Subject: **South Thomaston**

Federal Project No. BR-1674(500)S

State Pin No.016745.00

Amendment No. 4

TEMPORARY DETOUR
 Typical Fill Section

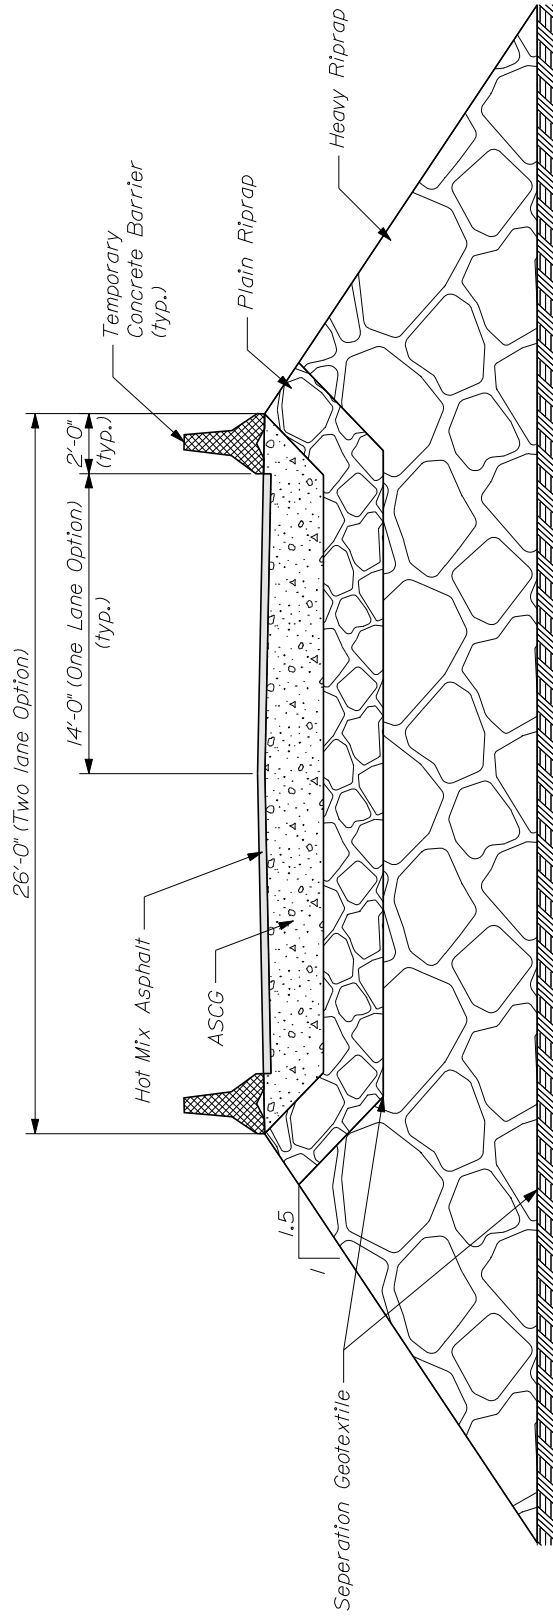
In the Bid Book, after page 93, **INSERT** the attached "TEMPORARY DETOUR, Typical Fill Section" diagram, 1 page undated and the "Temporary Rock Fill Area" plan view diagrams, 2 pages undated.
